Airly Mine Panel and Pillar Extraction Plan – Modification 2

AIRLY COLLIERY- ML1331
EXTRACTION PLAN - MINI WALL EXTRACTION
MW2-15 MODIFICATION 2- MW11-12
PLAN 8- Extraction Plan Area

DRG. No. AM02488

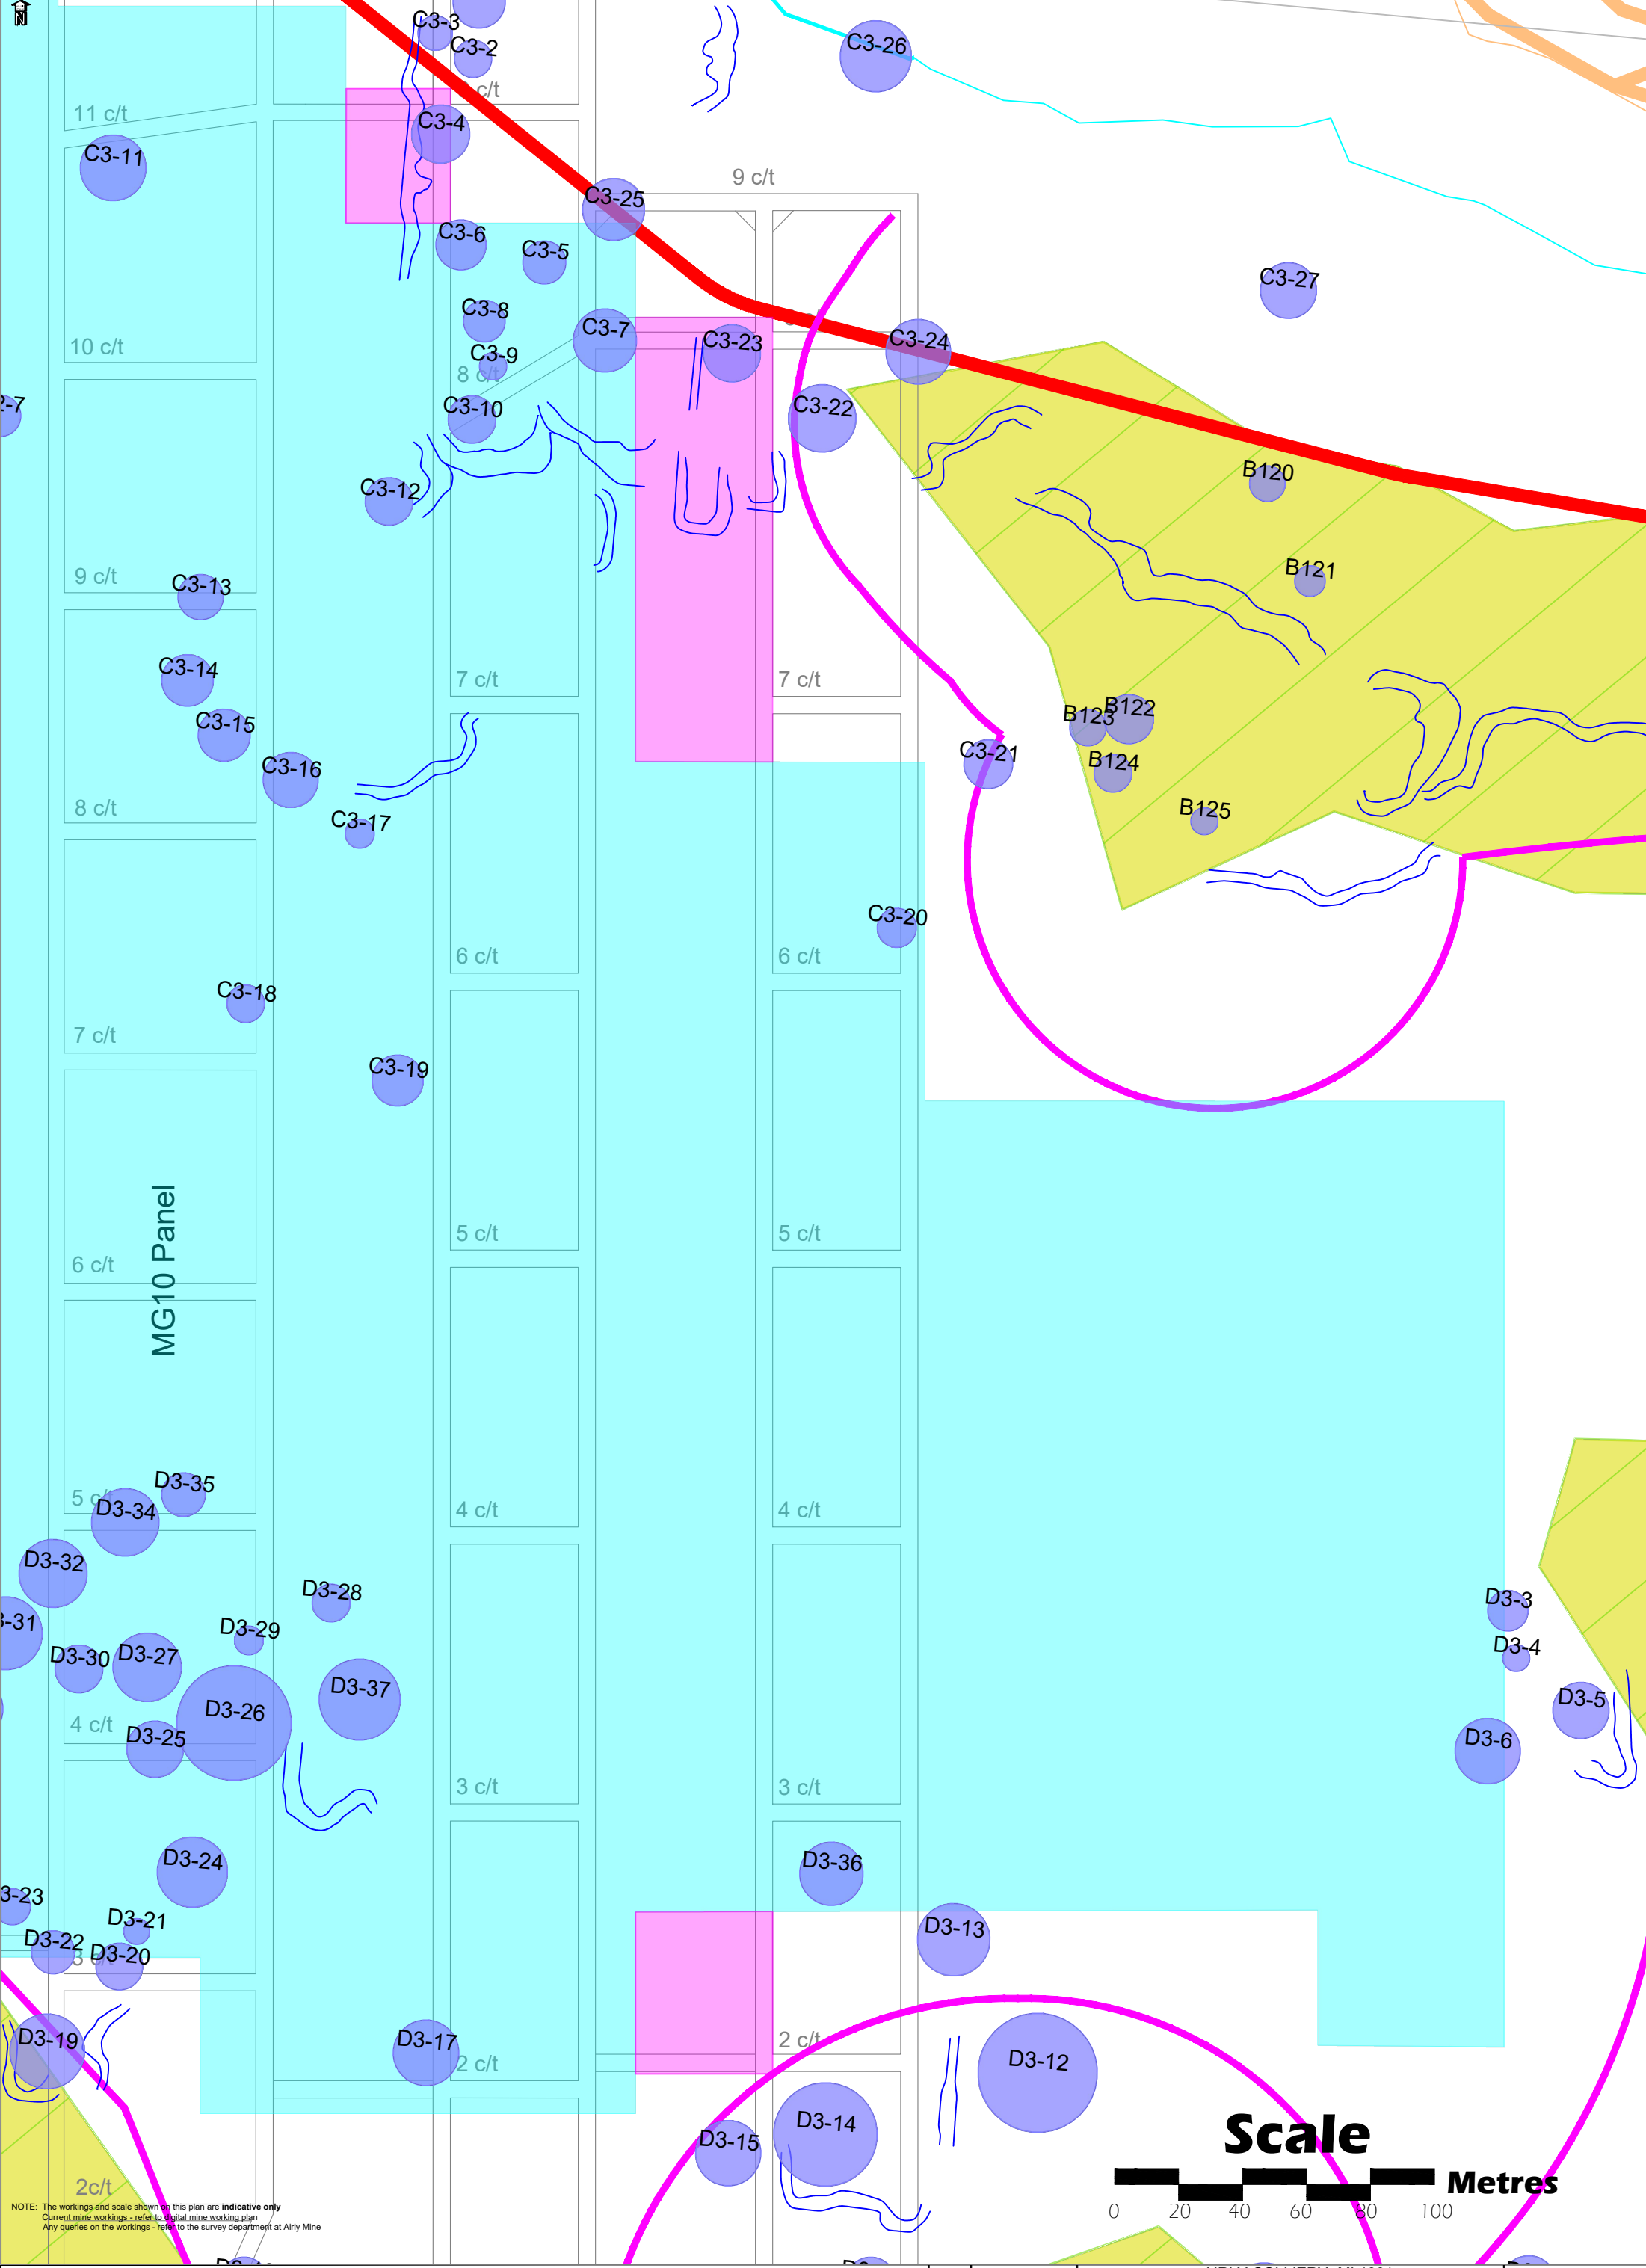
To bring subsidence back to within the EIS limit of 125 millimetres as soon as possible, investigations by SCT recommended an increase in the maingate 10 chain pillar size to form a barrier pillar followed by an increase to the regular chain pillar width for subsequent chain pillars. A number of scenarios were modelled which showed similar results. A 60 metre (solid) chain pillar width in maingate 10, followed by chain pillars in MG11 and MG12 of 40 metre (solid) width has been identified as the optimal mine design that would result in subsidence being reduced to less than 125 millimetres by the tailgate goaf edge of miniwall panel MW11. Detailed subsidence predictions for this mine design are presented in the SCT report attached as a supporting document to this Extraction Plan modification application.

SCT also recommended not mining more than miniwall panels MW11 and MW12 due to the likelihood of some strata failure occurring with wider spans even with the 40 metre chain pillars.

The revised mine design for the remainder of mining within the Mt Airly Panel and Pillar Zone is presented in attached figure (**AM02488**).

This Extraction Plan modification seeks a change in the mine design for miniwall panels MW10 - MW12 which are required to ensure vertical subsidence levels remain below 125 millimetres for the yet to be developed miniwall panels MW11 and MW12. The change in mine design results in minor changes to approved Extraction Area as presented in Figure **AM02488**. No further mining beyond miniwall panel MW12 is proposed under Mt Airly.
